**Reference no.: SDA\_79107**

Broken lid handle HD9160.

**Title: Broken lid HD9160**  
**From: Ruud Verbeek**  
**Valid Country: WEU, EEU, MEA**  
**Information for: All Repair specialists.**  
**Date: 02/04/2010**

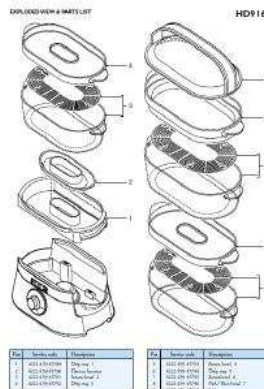
**Complain; the steamer lid handle is broken.**

**Models:** HD9160  
**Service part:** Lid  
**Service code:** 4222 459 45797  
**Pos:** 9

Year / week nr before week 1014 are infected and need to replace by lid after production week 1015.  
From week 1016 the improved lid (stronger material) is available by DHL.

The material of the lid is improved (<wk 1015) and can be used under normal conditions. Sent the consumer a new improved steamer lid 4222 459 45797.
